DATE: February 24, 2026

Owner: University of Maine

Engineer: DuBois & King, Inc.

SUBJECT: ADDENDUM NO. 3 TO THE BIDDING DOCUMENTS FOR
North Campus Parking Improvements

C4.1

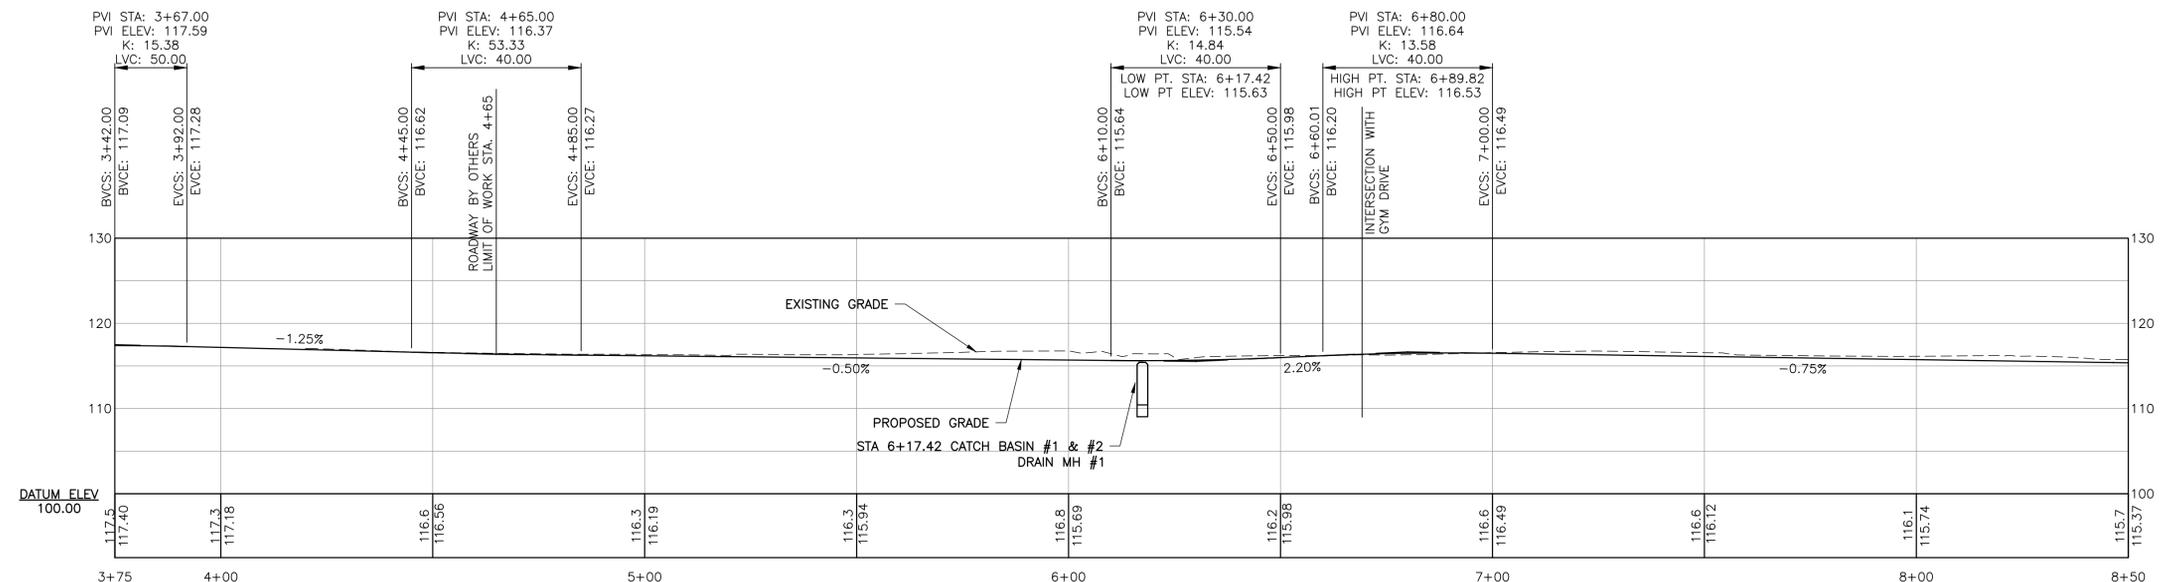
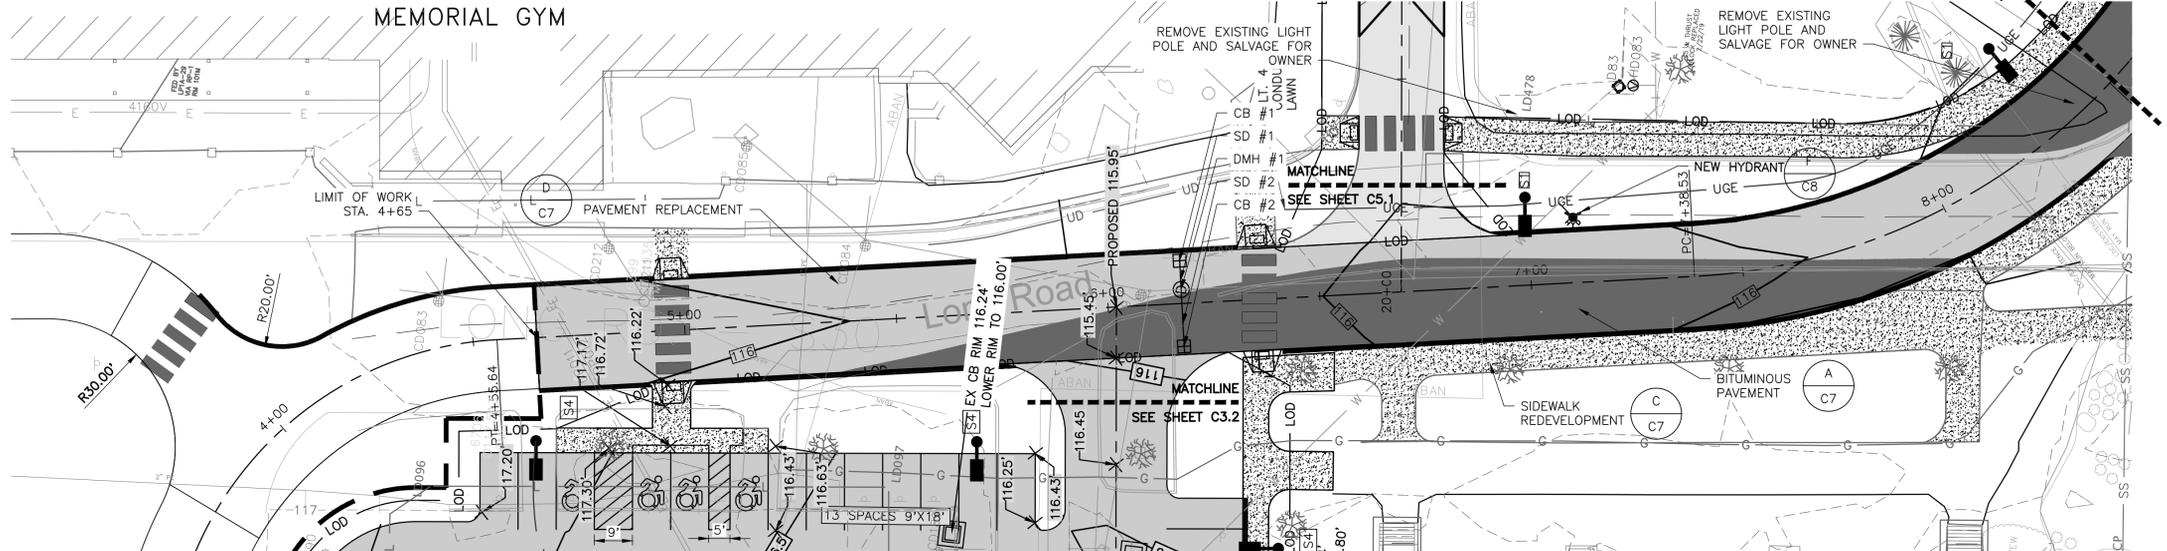
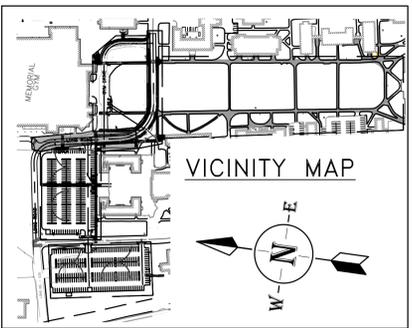
1. SHEET C4.1: Long Rd Plan & Profile Sta 4+65 to 8+50 Alt. 1
 - a. Revise Lighting Schedule for “Number of Lights” to read “2 New Lights (S1)”.
 - b. Revise Lighting Schedule for Note to read “Lighting includes fixture, 20’ poles, base, conduit, and related work.

NUMBER OF LIGHTS	DESCRIPTION OF LIGHTING
2 NEW (S1)	EQUAL TO WARP 9 LIGHT BY KIM
0 EXISTING REFURBISHED	PROVIDE NEW BASES AND CONDUIT

LIGHTING INCLUDES FIXTURE, 20' POLES, BASE, CONDUIT, AND RELATED WORK

C4.2

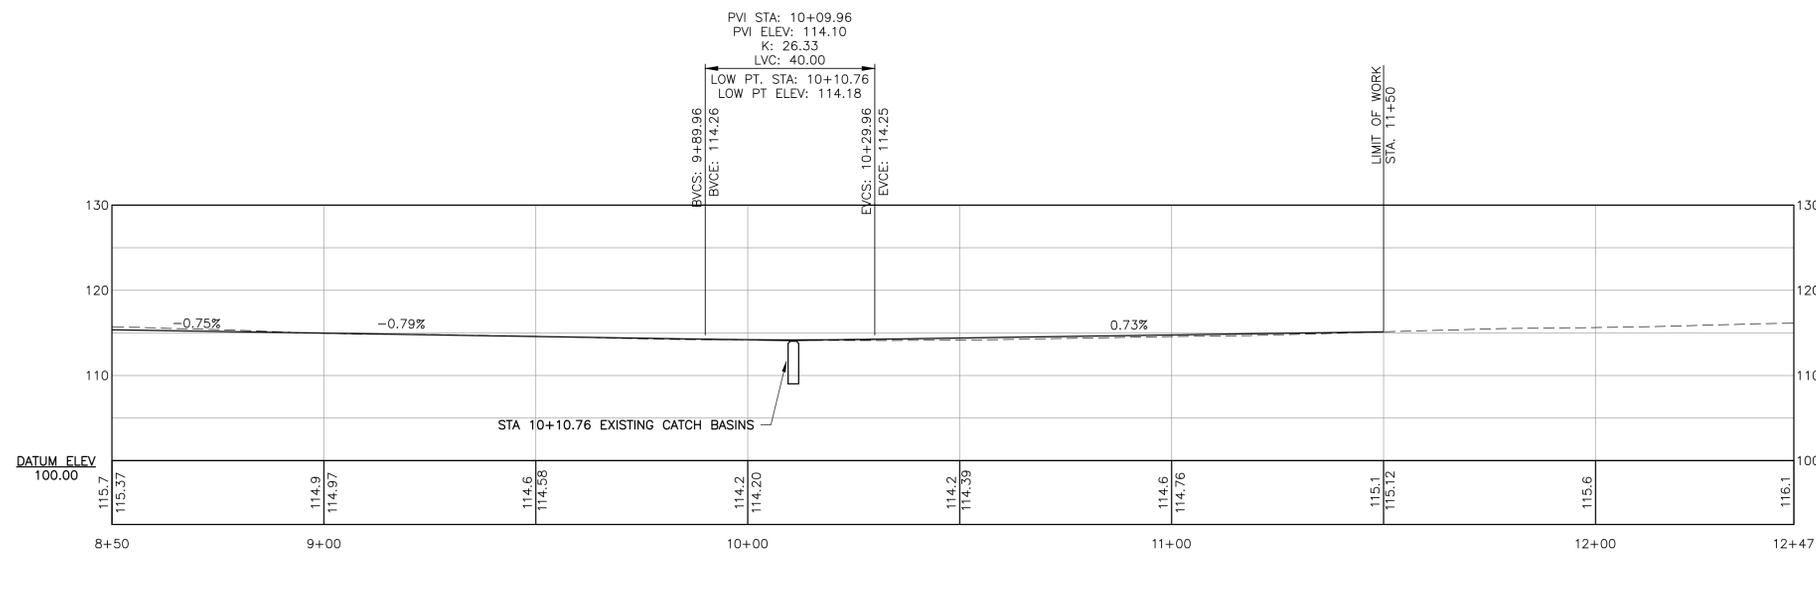
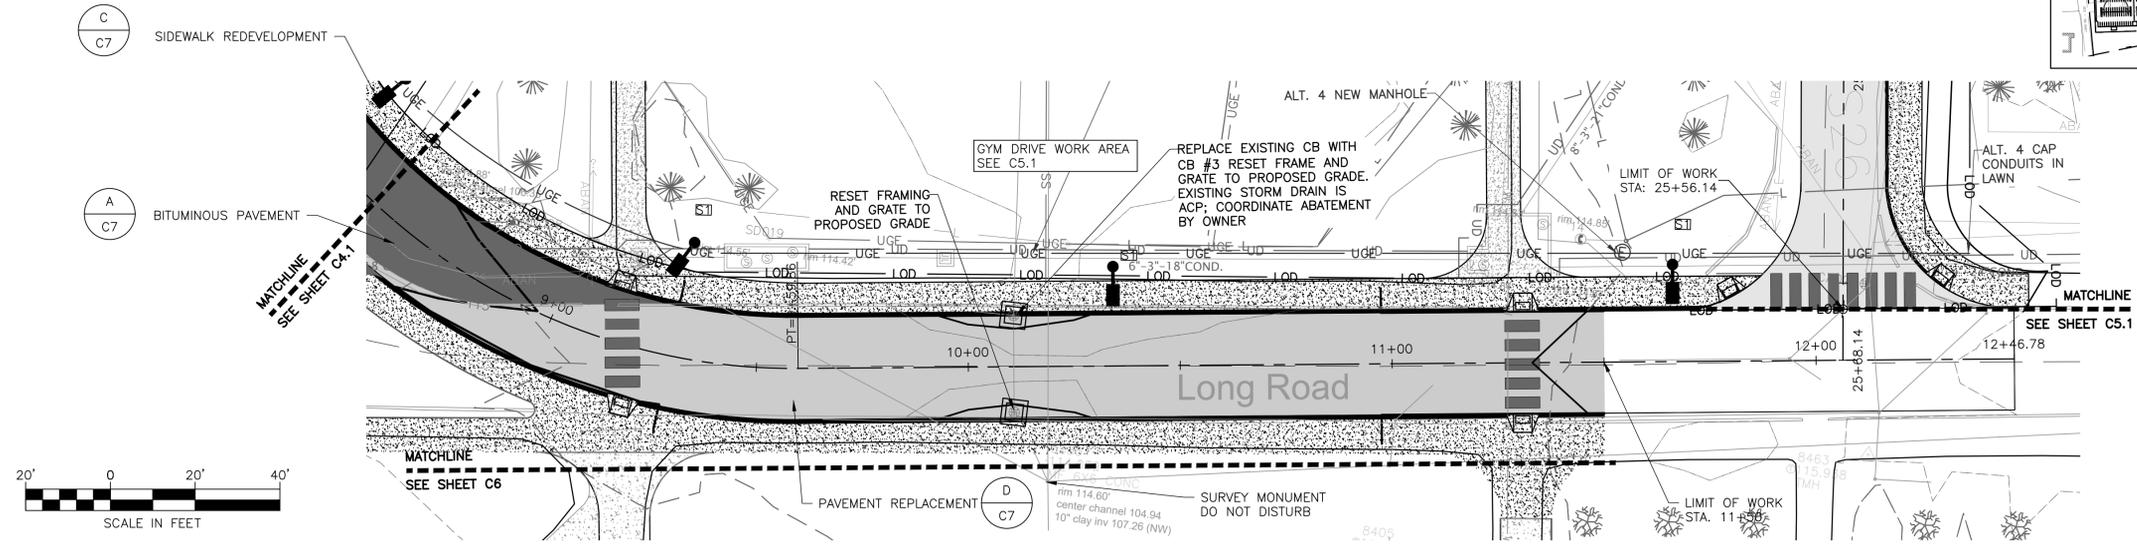
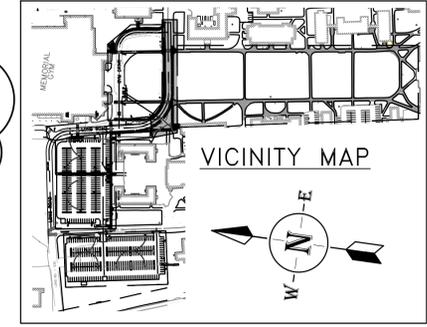
2. SHEET C4.2: Long Rd Plan & Profile Sta 8+50 to 12+47 Alt. 1
 - a. Revise Lighting Schedule for “Number of Lights” to read “3 New Lights (S1)”.
 - b. Revise Lighting Schedule for Note to read “Lighting includes fixture, 20’ poles, base, conduit, and related work.

LIGHTING SCHEDULE	
NUMBER OF LIGHTS	DESCRIPTION OF LIGHTING
3 NEW (S1)	EQUAL TO WARP 9 LIGHT BY KIM
0 EXISTING REFURBISHED	PROVIDE NEW BASES AND CONDUIT

LIGHTING INCLUDES FIXTURE, 20' POLES, BASE, CONDUIT, AND RELATED WORK
